80
CHARLOTTE
STREET.
FITZROVIA W1

67 Whitfield Street Change of Use Application - Addendum

Date
April 2021

Stage/Revision Number
Planning

Proposed Ground Floor Plan - Services

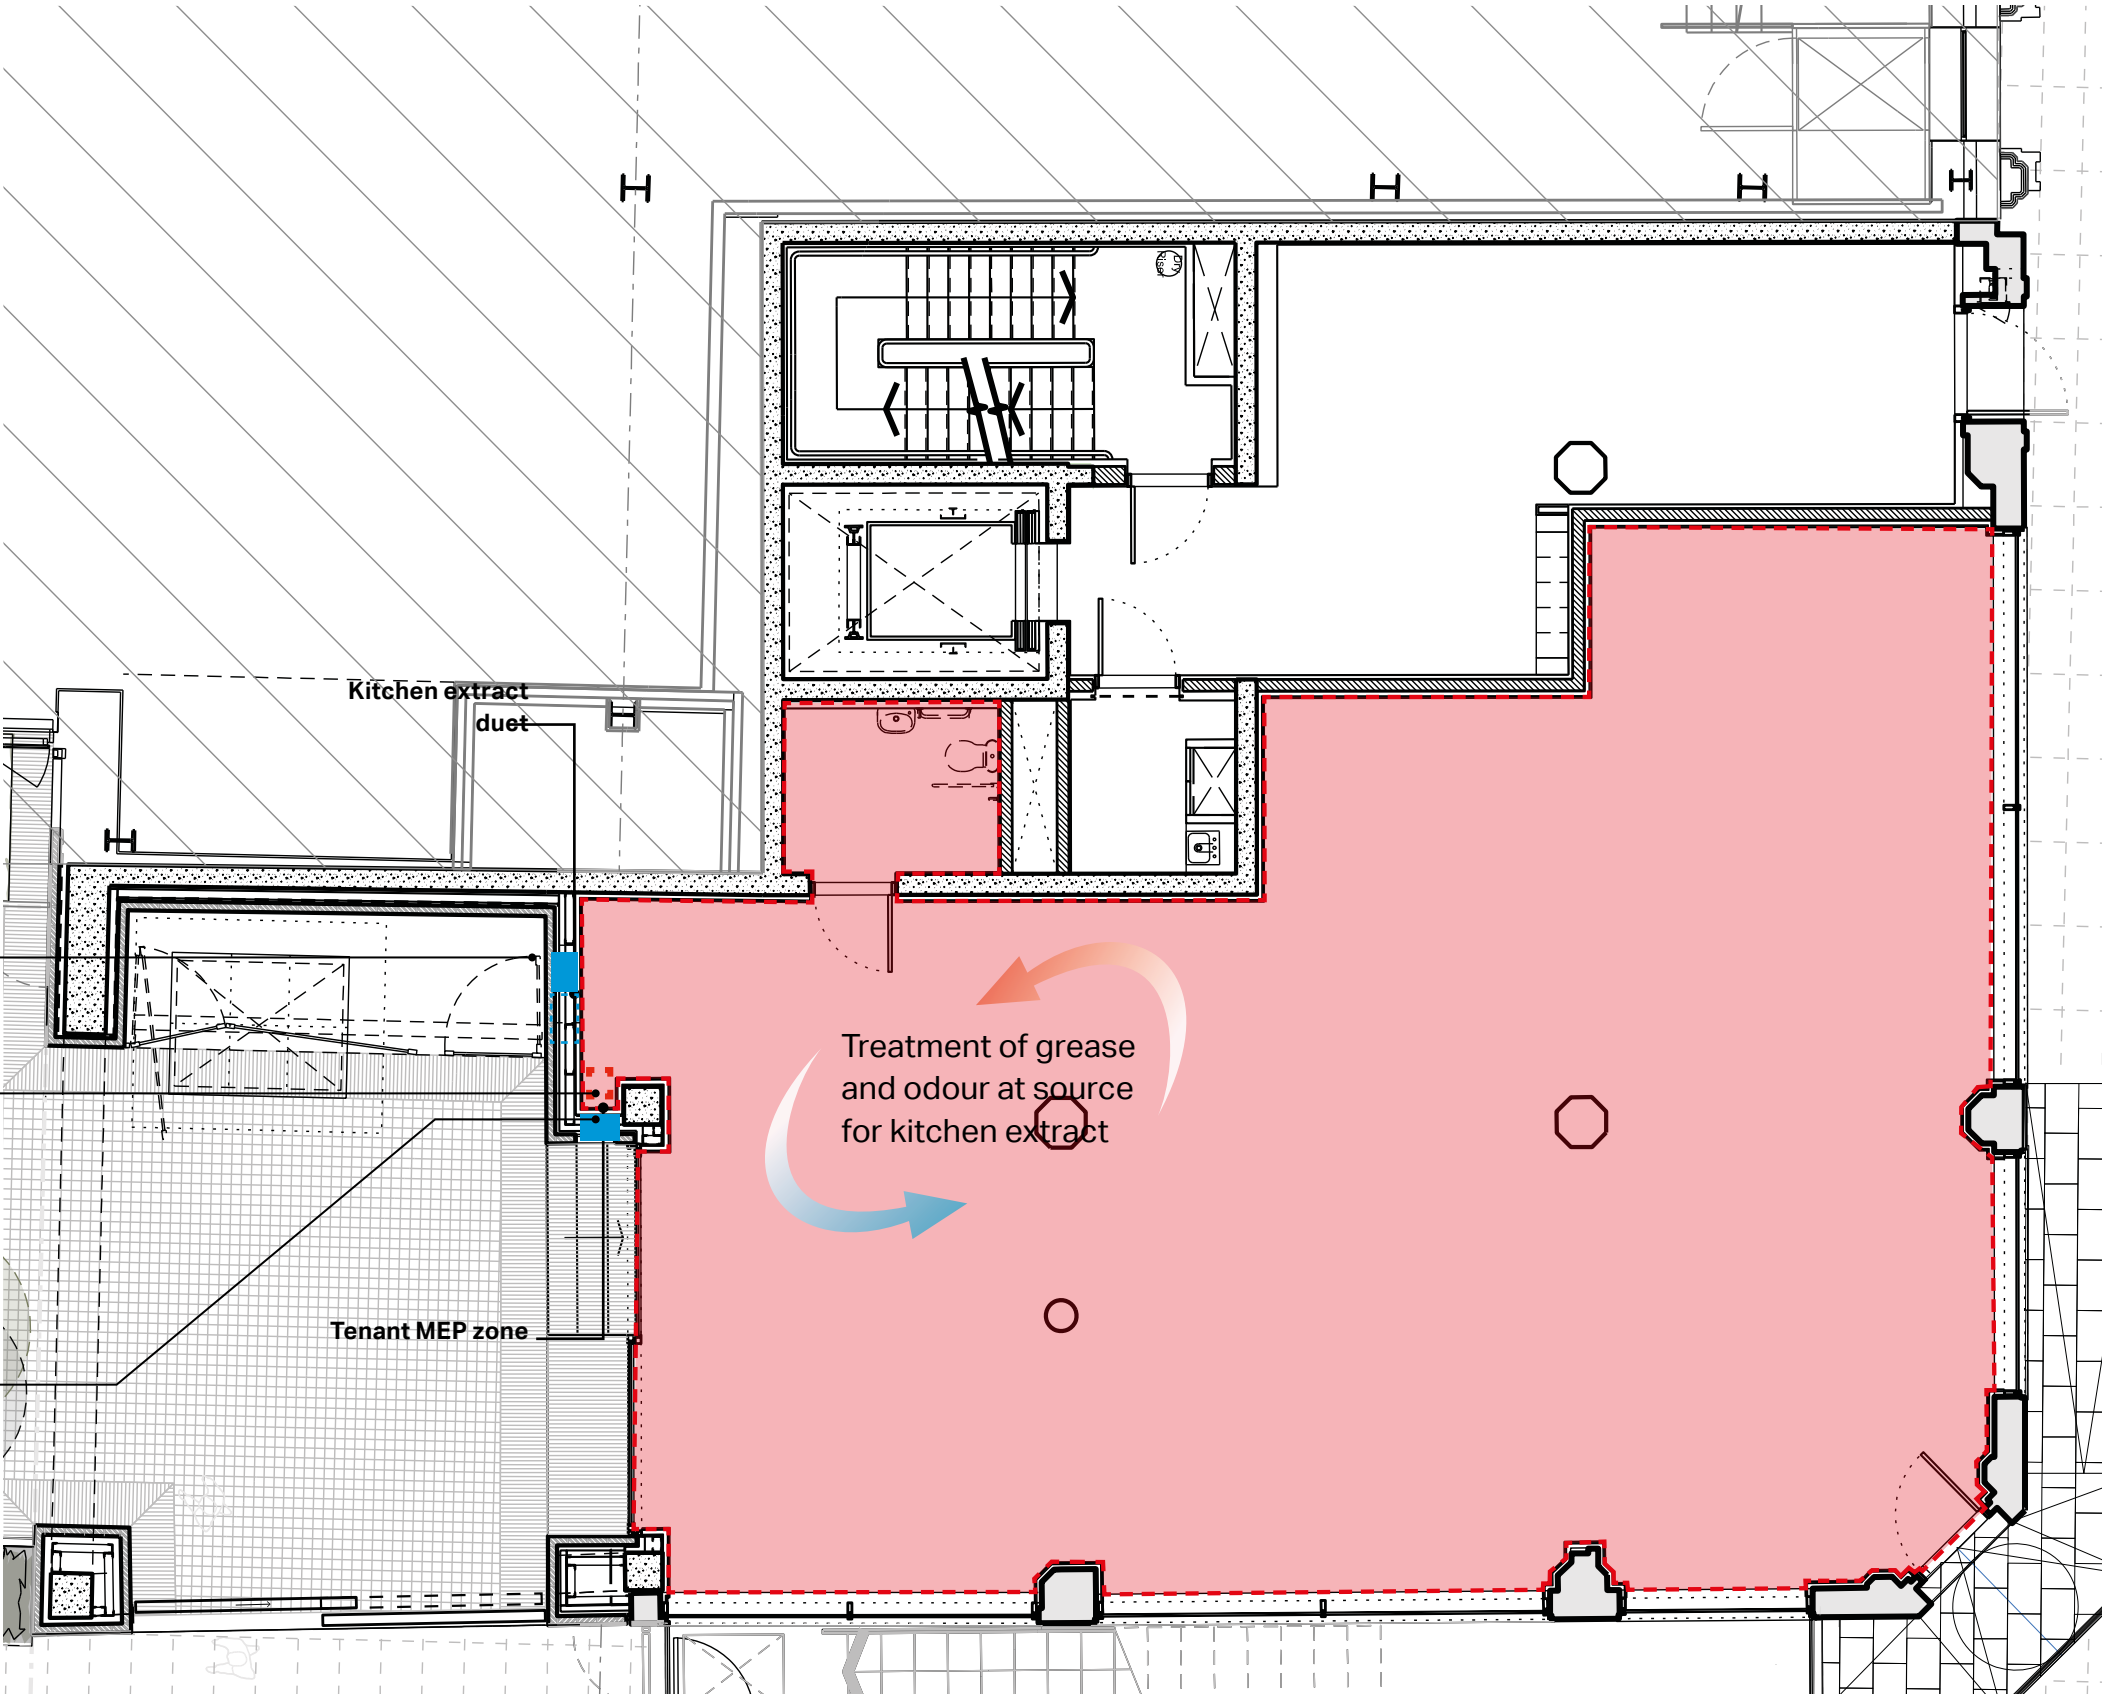
300x150mm vent in wall to outside for WC extract at high level (as per base build provision).

Additional extents of vent opening to incorporate new general extract vent in change of use.

Dedicated zone for tenant MEP.

Full height louvre for intake for ventilation (500mm W x 3100mm H).

Pocket park Elevation

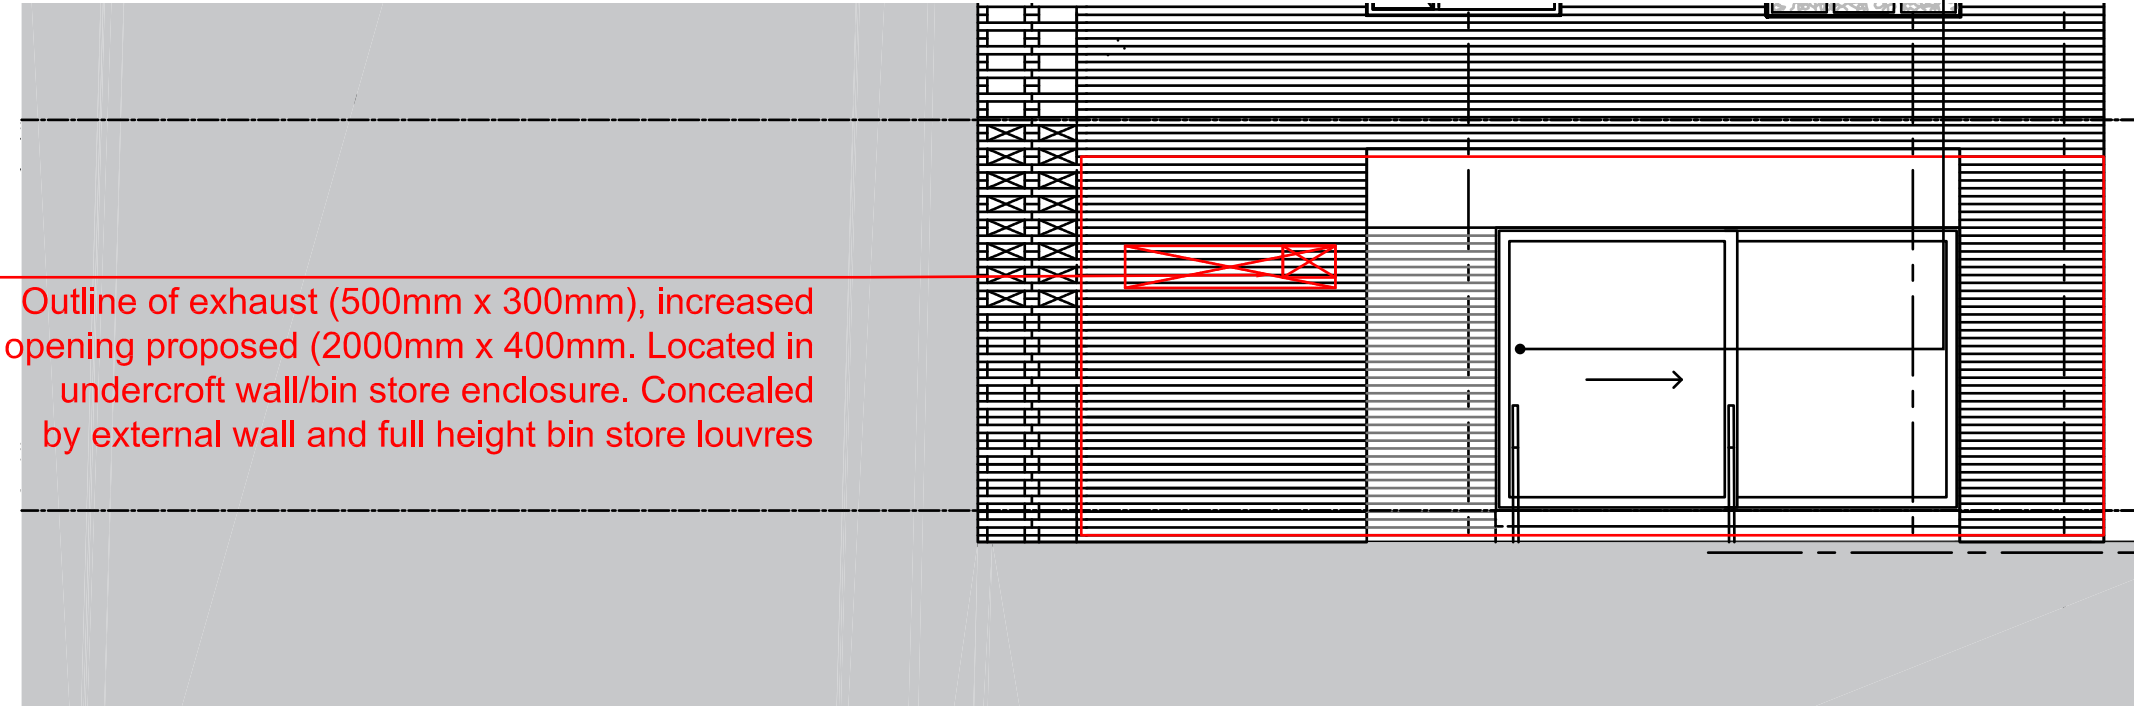
Outline of exhaust (500mm x 300mm), increased
opening proposed (2000mm x 400mm. Located in
undercroft wall/bin store enclosure. Concealed
by external wall and full height bin store louvres

Full height louvre for intake for ventilation
(500mm W x 3100mm H). **Note** This is installed as part of base
build provision, no increase required.

Bin store elevation (Screened enclosure)

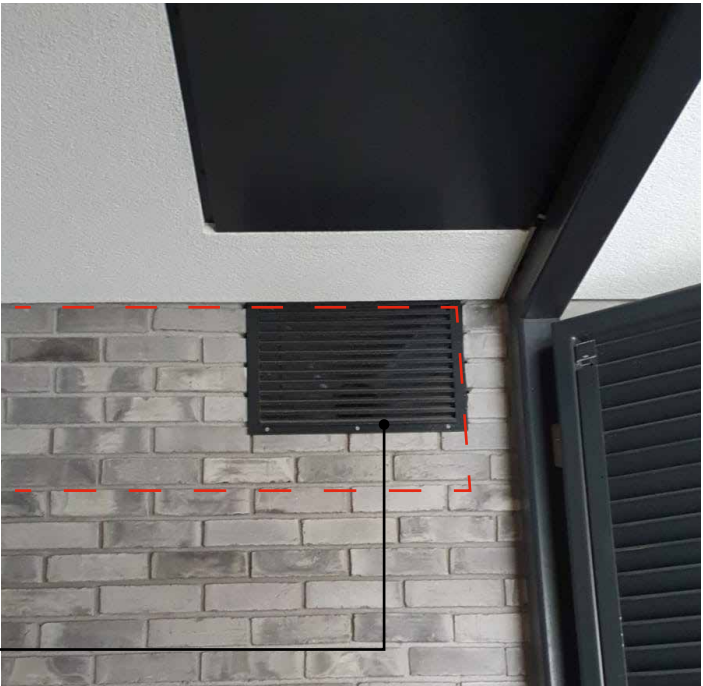
Exhaust louvre
concealed by screen

Exhaust louvre as installed,
increase required for change of use
